<Reference: 92384167E-FA>

15 July 2021

## Urgent Field Safety Notice – Urgent Medical Device Recall EMBLEM™ S-ICD Subcutaneous Electrode (Model 3501) with Reply Form/Product List

**Table 2.** Users may distinguish affected/original EMBLEM Electrodes and the enhanced EMBLEM Electrodes through part number and packaging.

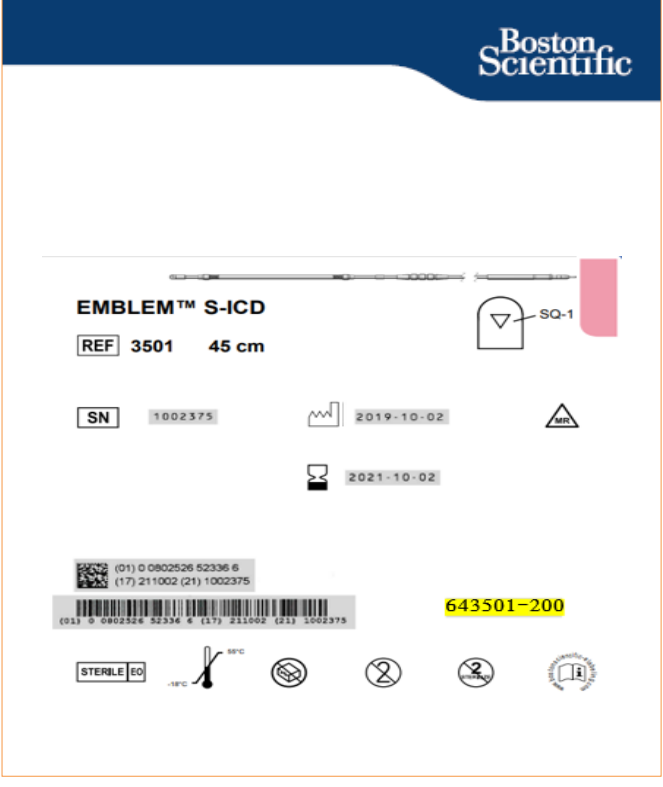
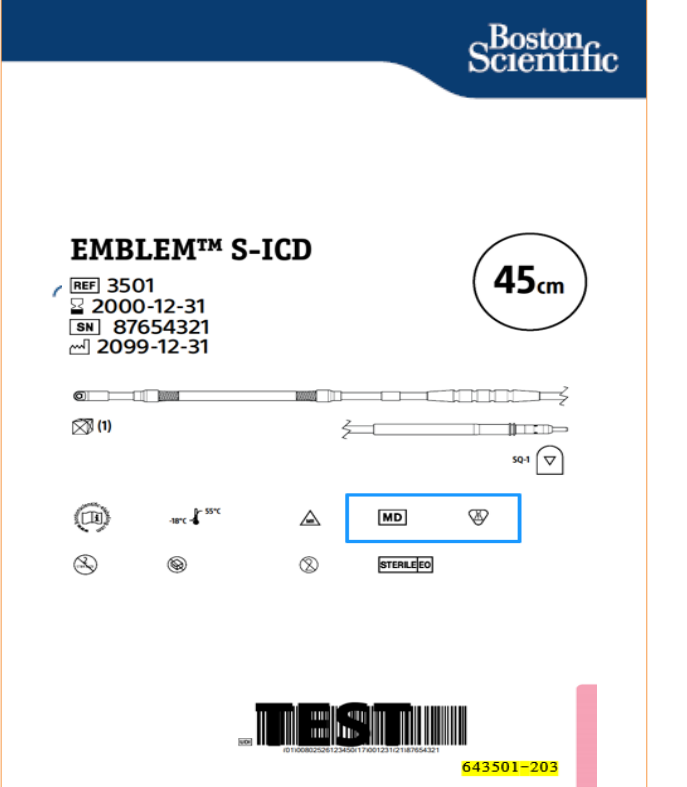
<b>Remove and Return</b> <b>Affected/Original EMBLEM Electrode</b>	<b>In Service</b> <b>Enhanced EMBLEM Electrode</b>
<p>When enhanced electrodes are available at your facility, return EMBLEM Electrodes with 9-digit part numbers ending in <u>0</u> or <u>1</u> (e.g., 643501-20<u>0</u> ends in <u>0</u> and is to be returned).</p>	<p>Enhanced EMBLEM Electrodes include 9-digit part number ending in <u>3</u> or higher may be placed in service (e.g. 643501-20<u>3</u>, ends in <u>3</u>).</p>

<p>The affected/original EMBLEM Electrode is potentially susceptible to electrode body fractures distal to the proximal sense ring. This packaging may also include literature describing the electrode body fracture behavior described in Dec 2020.</p>	<p>The enhanced version of the EMBLEM S-ICD Subcutaneous Electrode includes design enhancements to the proximal sense ring to address electrode body fractures distal to that location and changes to packaging for continued conformance with labeling requirements (items highlighted in yellow and blue square to show significant changes)</p>
